Re: Change Request Proposal – 190422
Credit for Flush Granite Curbs

15027: Dover High School and Career Technical Center

Change Request Proposal 190422

Title PR-91 - Flush Granite Curbs
Date Issued 10/17/2019
Proposal Status Submitted (Not Proceeding)

5 FLUSH GRANITE CURB
Scale: 1"=1'-0"

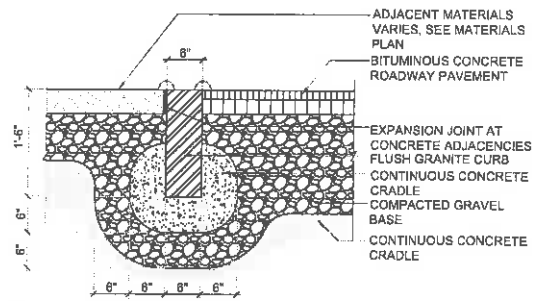
The CDs include flush granite curbs at the tilt-downs (ADA warning plates). Granite is not allowed in these locations in the City of Dover.

We have been notified that the City of Dover does not allow flush granite curb between the asphalt roadway and the detectable warning tiles. They require the asphalt to go all the way to the warning tile. This is contrary to detail 6/L4.1. Please review with the City of Dover and provide direction on this issue. We are scheduled to install curbing at the West end of the building on 4/18/18.

1. Tip down the granite curb on each side of the curb ramp as previously shown.
2. Delete and do not install flush granite curb between concrete ramp and asphalt road paving.
3. Extend the concrete ramp paving to the front face of the vertical granite curb, essentially replacing the deleted flush granite curb with concrete paving.
4. The cast-iron detectable warning tiles would be installed in locations previously shown.
